Subject: AP1000 COL Responses to Requests for Additional Information (TR 85)

Westinghouse is submitting responses to the NRC requests for additional information (RAIs) on AP1000 Standard Combined License Technical Report (TR) 85, APP-GW-GLR-044, Nuclear Island Basemat and Foundation. These RAI responses are submitted in support of the AP1000 Design Certification Amendment Application (Docket No. 52-006). The information included in the response is generic and is expected to apply to all COL applications referencing the AP1000 Design Certification and the AP1000 Design Certification Amendment Application.

# AP1000 TECHNICAL REPORT REVIEW

RAI Response Number: RAI-TR85-SEB1-05  
Revision: 0

Figure RAI-TR85-SEB1-19-1 Analysis Soil Model (Sand&Clay Site)

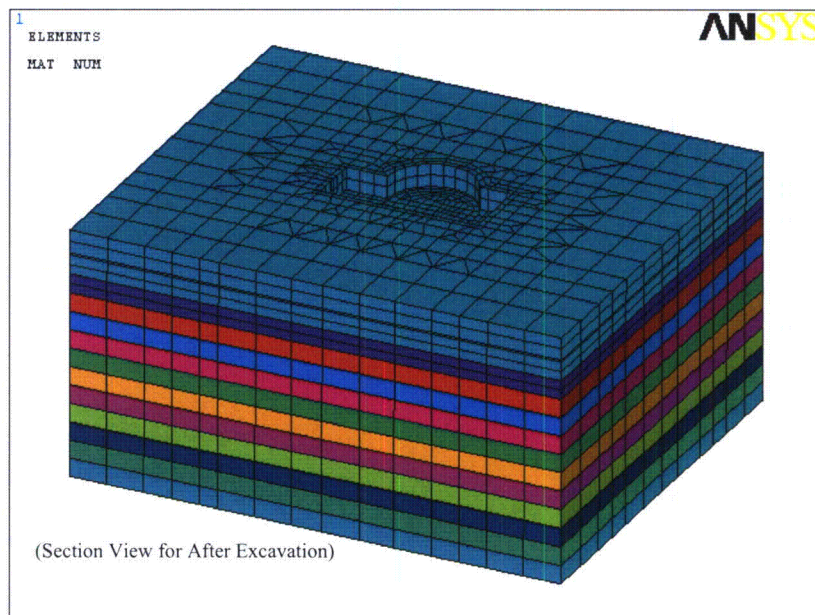
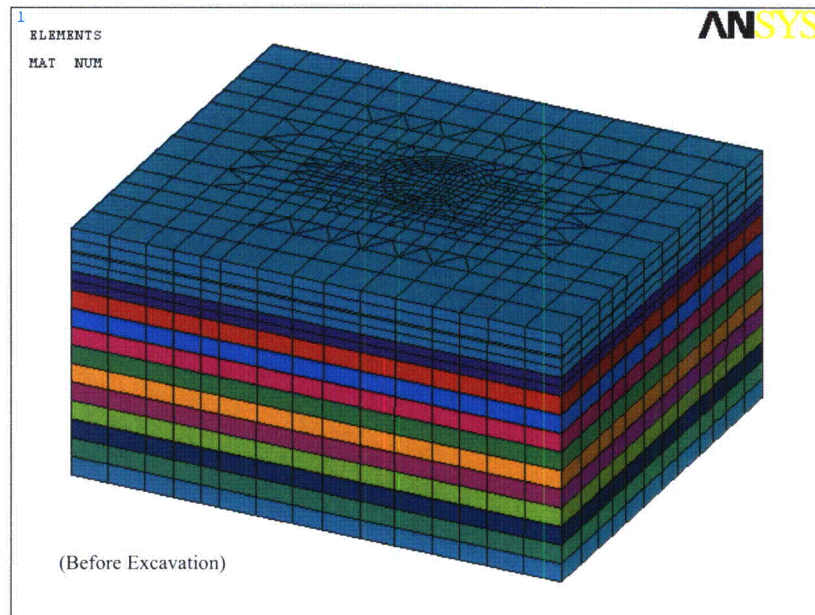
- a. Describe the analysis and design approach used to calculate the basemat and foundation wall member forces considering settlement during construction for the three alternative construction sequences.

- b. Describe how the confirmatory evaluation was performed to demonstrate that the member forces due to design basis loads, including locked-in forces due to construction settlement, remain within the capacity of the section.

- a. Settlement during construction is evaluated in non-linear analyses of a finite element model of the soil and nuclear island. The soil model is shown in Figure RAI-TR85-SEB1-19-1. Immediate settlements are based on elastic properties of the foundation medium, while the time-related settlements use creep parameters established by comparison against one-dimensional consolidation theory. The nuclear island uses the NI05 building model described in DCD Appendix 3G, subsection 3G.2.3. The construction sequence and history of loading are represented by finite time steps (the analysis uses 12 to 16 steps). Concrete placed during a time step is not considered to have structural strength until the beginning of the next time step. Structural forces and moments are extracted from the last iteration of each time step of the analysis.
